Preliminary Design Report Addendum (TII Departure No. 36213)

N2 Road, Ardee (Ardee 2040 Regeneration Project)

April 2025

Title: **STAGE 2 ROAD SAFETY AUDIT**
For;
Main Street Ardee

Figure 1: Extract from Proposed Site Layout

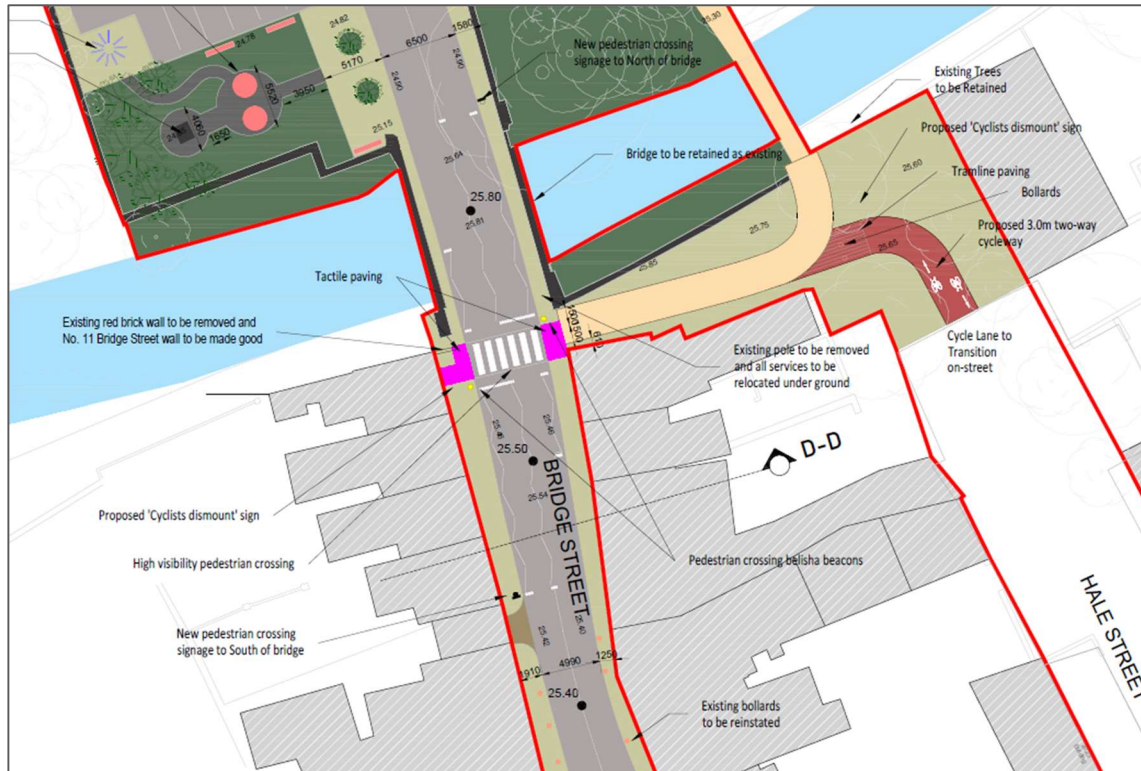
7. The following summarises the characteristics of the proposed amended design. The amendments relate to the portion of the proposed development located on / to the south of the existing bridge at Bridge Street (see **Figure 1**):

- The raised table has been removed from the proposed design. The proposed road at this section of the proposal will have a standard kerb height of 125mm. This will ensure the structural integrity of the existing bridge is not impacted and improve safety for pedestrians crossing the bridge through the inclusion of a vertical change between the public road and footpath.

- The proposed high visibility pedestrian crossing will be realigned to be perpendicular to the footpath and will be accessed via a dropped kerb. Tactile paving is positioned on either side of the crossing. Belisha beacons are proposed on both sides of the crossing to ensure that approaching vehicles are aware of the crossing.

- It is proposed that the existing brick wall adjacent to no. 11 Bridge Street will be removed and the wall of no. 11 Bridge Street made good.
 - The existing wall to the south west corner of the bridge (protected structure), adjacent to the access to the riverside walk, will remain unaltered. The removal of the adjacent brick wall will provide an opening width of approx. 1.36m. The existing opening width is 0.96m therefore the proposed layout will improve the existing situation.

- Signage is proposed to the north and south of the high visibility crossing advising vehicles travelling south and north that there is a pedestrian crossing ahead.

- The walls of the bridge, a protected structure, have been accurately shown on the existing and proposed drawings.
8. The proposed amendment will not have an impact on any existing / proposed vehicular junctions therefore the visibility splay / auto tracking details remain as previously proposed.

Drawing HDC1256 107 Rev 07, South of Dee River bridge.

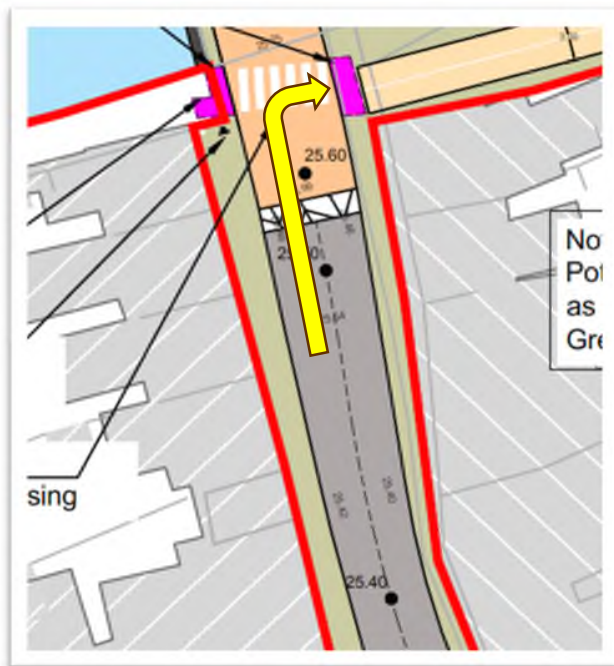
There is no provision for northbound cyclists to exit the N2 and wait to cross the signalised crossing. Cyclists will therefore continue travelling northbound on the Main Street carriageway thereby increasing the risk of collisions with general traffic. A proposal to direct cyclists via Hale Street was suggested in the Feedback Form of the Stage 1&2 Road Safety Audit. That proposal does not appear to be included in this design update.

It is recommended that a transition from on-road to off-road be provided for cyclists.

Drawing HDC1256 106 Rev 06, Ash Walk, tie in with link road to the N52.

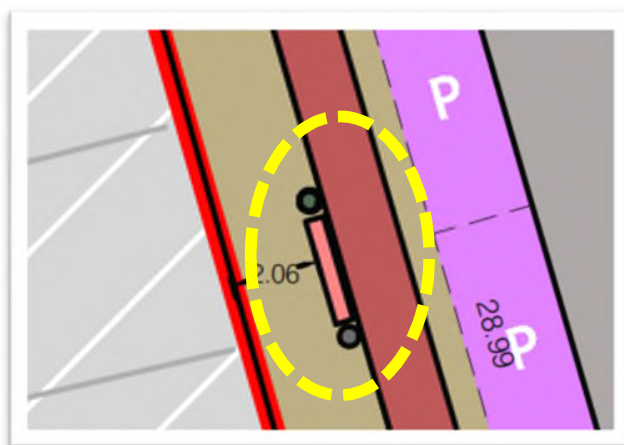
The link road to the N52 from Ash Walk is not shown to be a shared street. A change of street type could increase the risk of collisions with vulnerable road users.

It is recommended that that consistency in street type be provided or that a suitable transition be provided.

Drawing HDC1256 106 Rev 06, benches adjacent to the cycle lane.

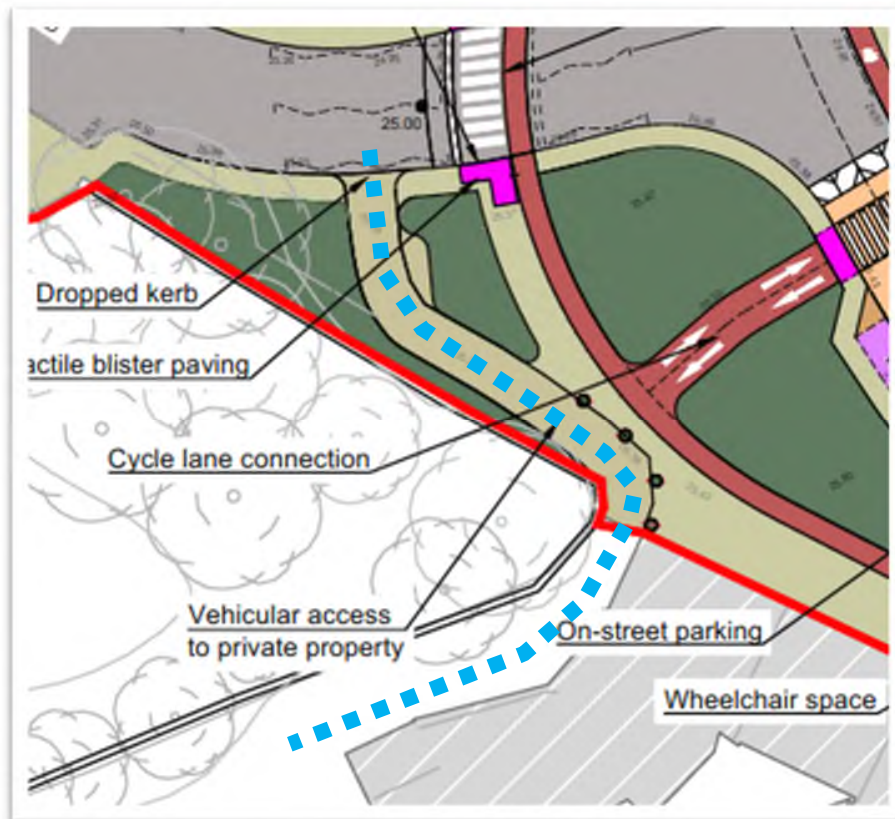
It is proposed to provide benches adjacent to the cycle track. If they are located too close to the cycle track they may be hazards for cyclists who may get their handlebars caught leading to loss of control and falls.

It is recommended adequate offset be provided at the edges of the cycle track without obstacles.

Drawing HDC1256 1002 (K) Rev 03 Kerb Layout, Access to private garage off N2.

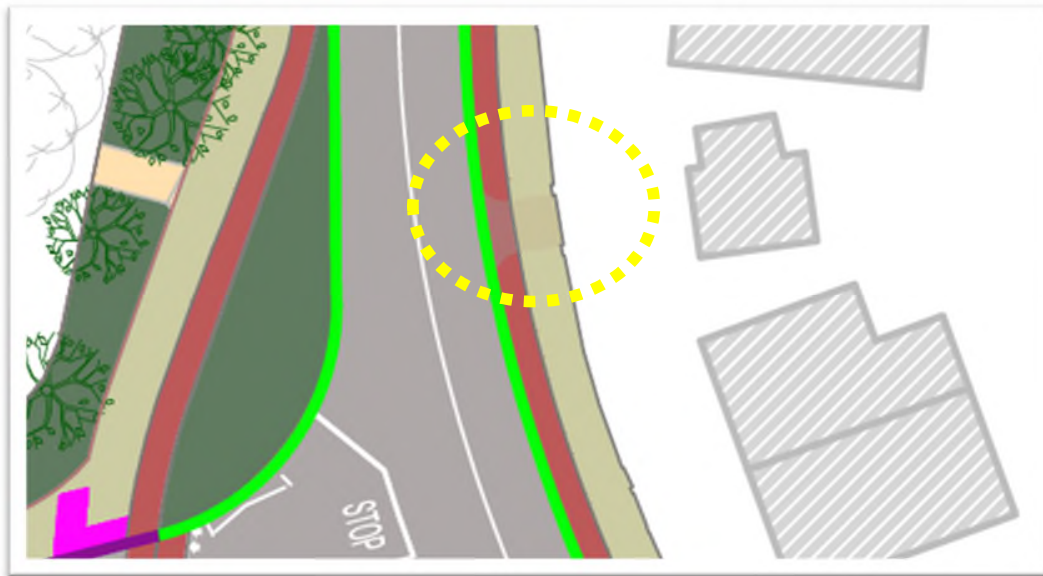
The drawing shows a 125mm high kerb at the proposed vehicular access to the private garage on the eastern side of the N2 just north of the Golf Links Road junction. A high kerb could lead to vehicles 'bouncing back' when trying to access the driveway to the garage resulting in rear-end collisions.

It is recommended that the kerb height be adjusted to facilitate vehicular access.

Drawing HDC1256 1002 (K) Rev 03 Kerb Layout, 50mm high kerbing at accesses.

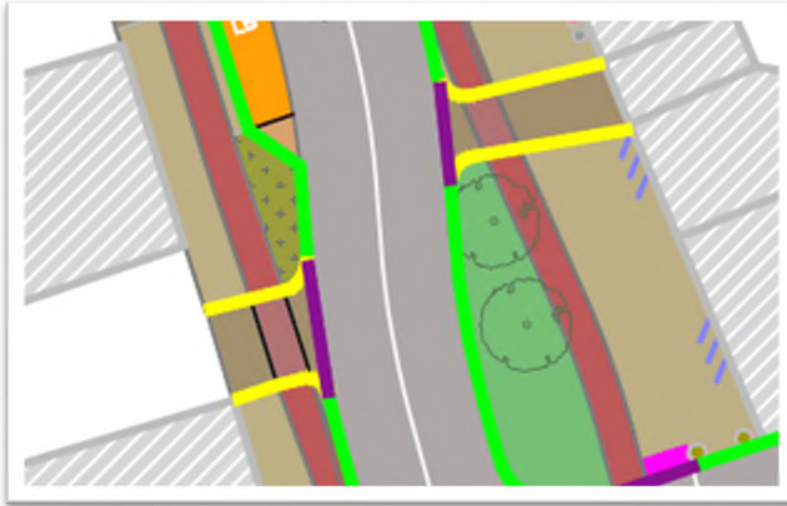
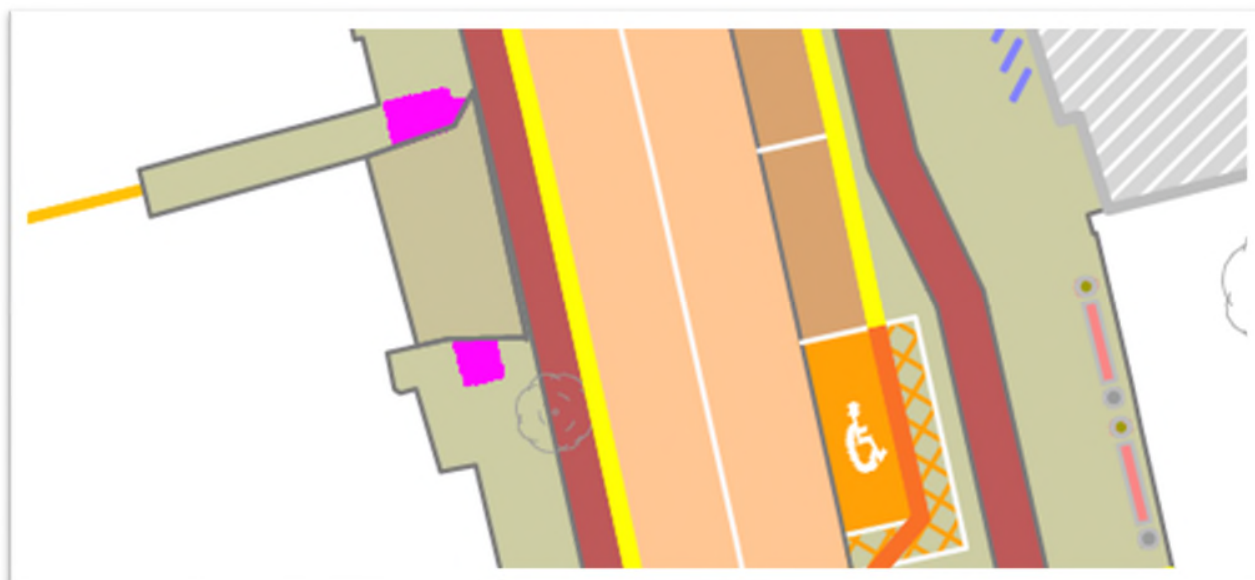
It is proposed to provide 50mm high kerbing at some accesses across the footpath. This would be a trip hazard and would lead to inaccessibility for mobility impaired pedestrians.

It is recommended that flush kerbs be used or no kerbs and that continuous footpath and cycle track facilities be used.

Drawing HDC1256 1007 (VT) Rev 05, At zebra crossing.

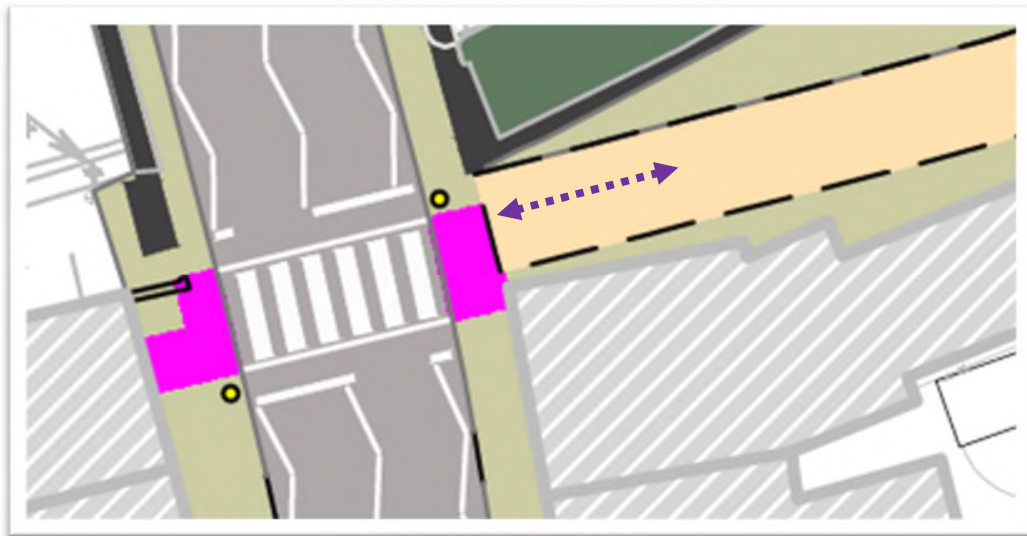
It is proposed to provide a road gully at the zebra crossing. This could lead to narrow wheels getting stuck or to those wearing narrow heels getting stuck and injured. There is also a risk that if the gully becomes blocked that surface water ponding will take place at the crossing location which could result in pedestrians crossing at another location where drivers do not expect or to slips and falls in icy conditions.
